**Stormwater Addendum 3
for
Fearing Hill Road Solar Project
Wareham, Massachusetts**

**September 2, 2022
Atlantic Project No. 3055.02**

This addendum to the 5/17/2021 Stormwater Drainage Analysis for the Proposed Fearing Hill Road Solar Project in Wareham, MA has been prepared to address follow-up e-mail comments received from the Town's consulting hydrogeo engineer Horsley Witten Group, as well as items discussed at the 8/16/22 meeting with Horsley Witten Group and the Town's reviewing consultant Charles Rowley.

Outlet #1 (10" culvert) - Qpeak=3.99 cfs; Vpeak=7.31 fps

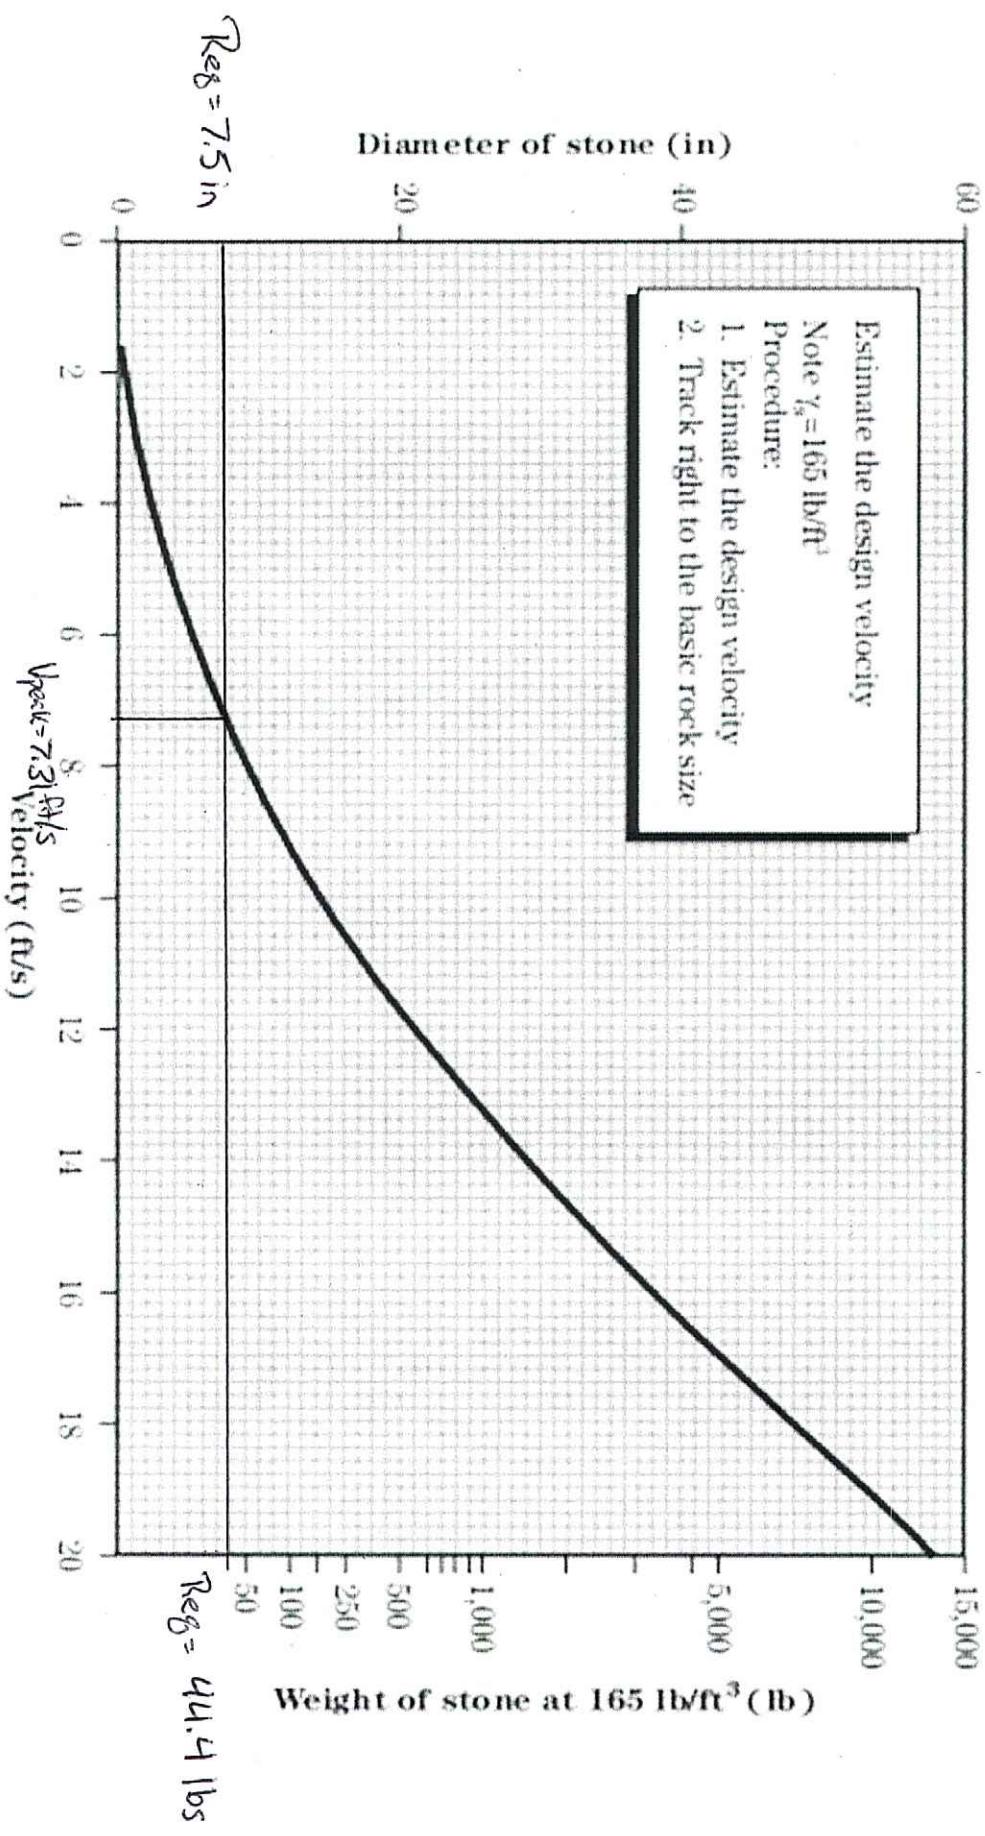
The sizes of rip-rap aprons and impact basins are now revised on the plans, based upon these calculations. The level spreader sizes as proposed were found to be more than adequate. The Rip Rap calculations were adjusted to use the Vpeak from HydroCAD and the provided Rip Rap size was adjusted from 6" to a minimum of 8".

Vpeak= 7.31 fps (From HydroCAD calculations-100yr storm)

From Isbash Curve; required D_{50} = **8 inches**

Post-Development Watershed Plan – Entrance Swale

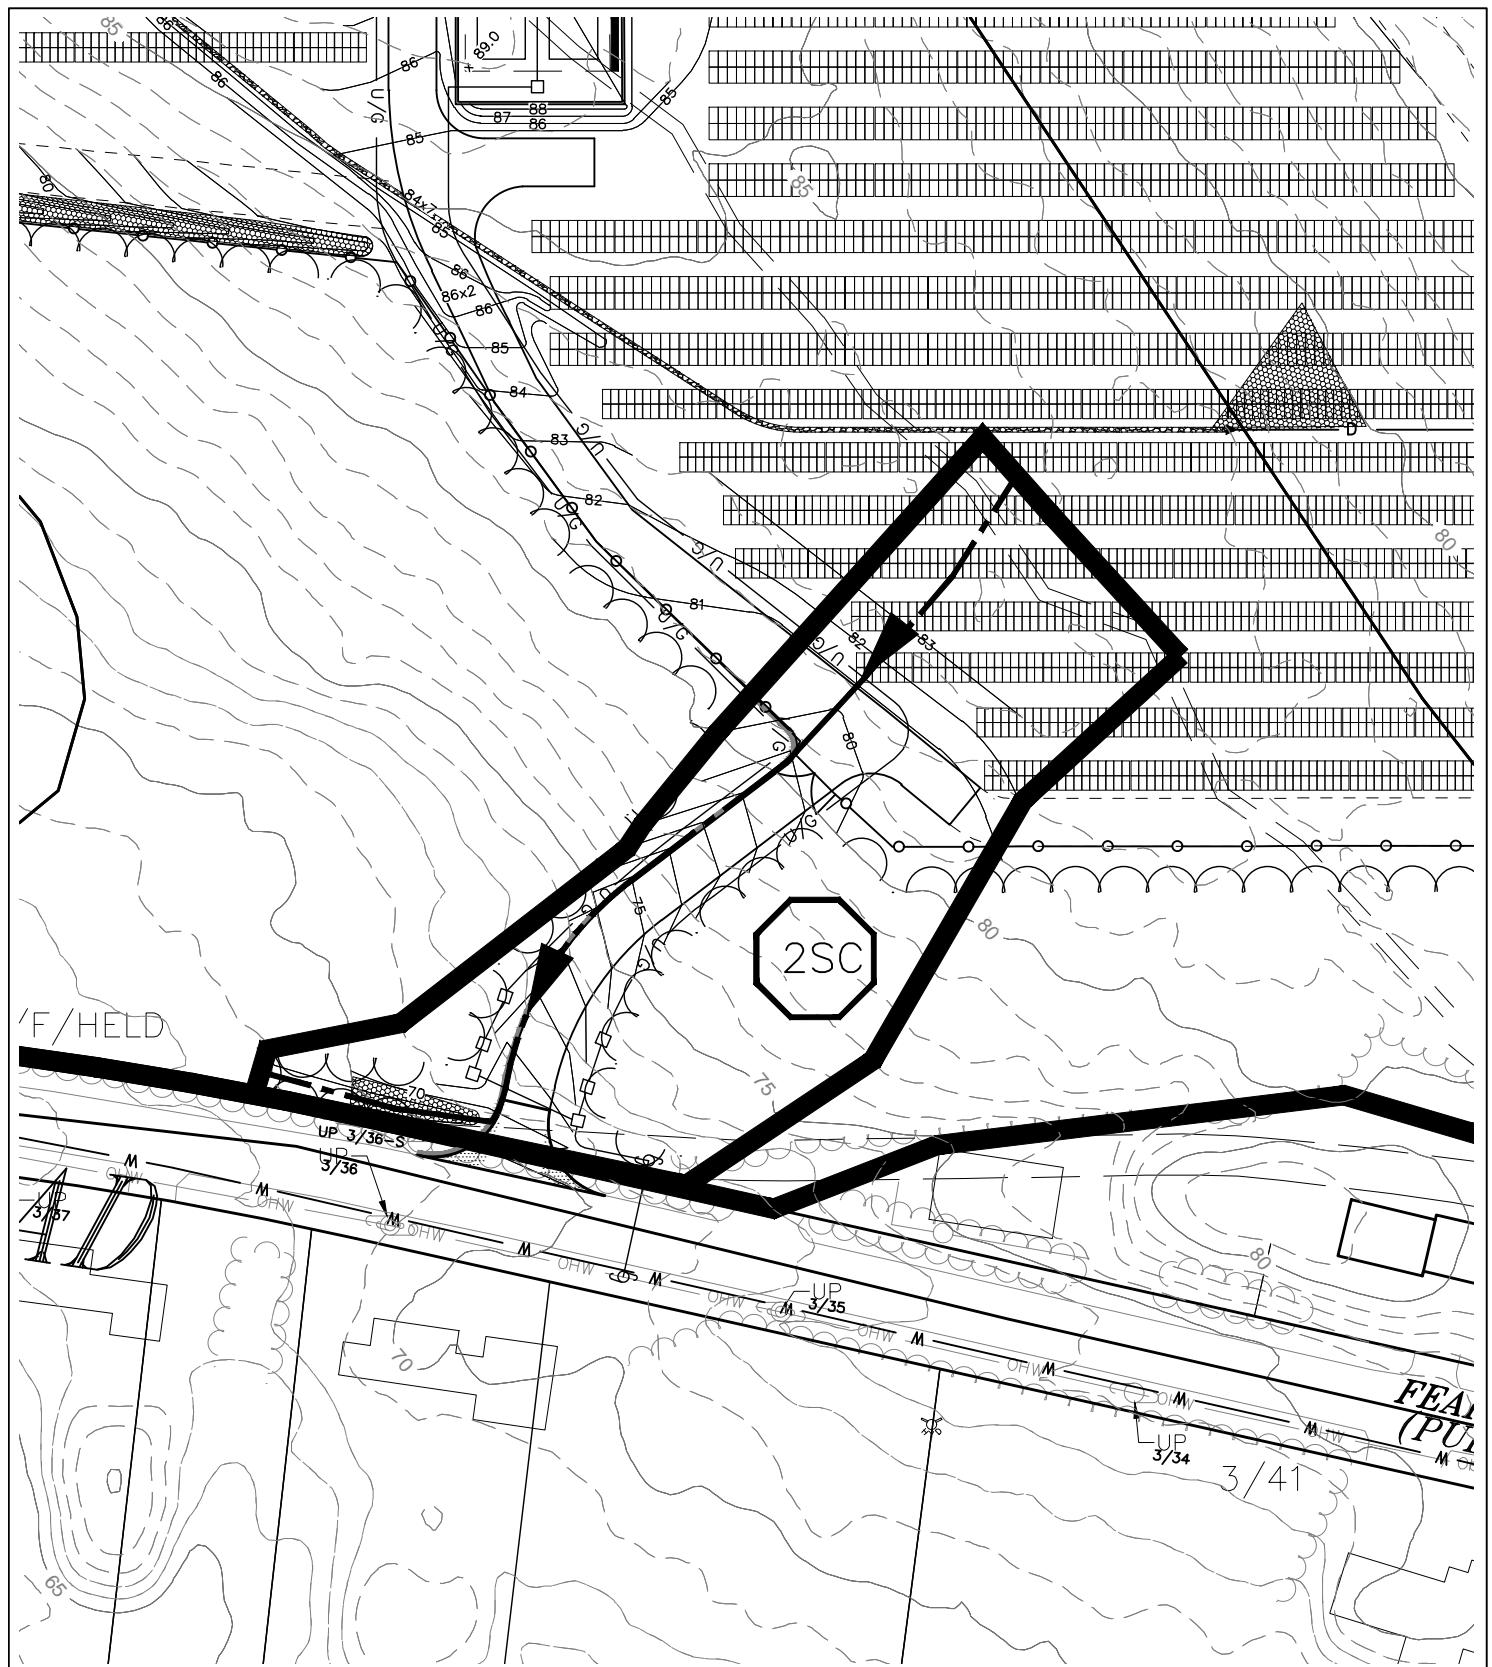
- Pos-Development HydroCAD analysis was developed to analysis the portion stormwater runoff generated and contributing the proposed swale at project site entrance.

Calculations show that the swale designed at the entrance of the site will maintain all generated runoff in the 100-year storm without overtopping to Fearing Hill Road. The rip rap swale will convey all stormwater along the natural channel along the northern side of Fearing Hill Road ultimately leading to the Railroad Bed design point.
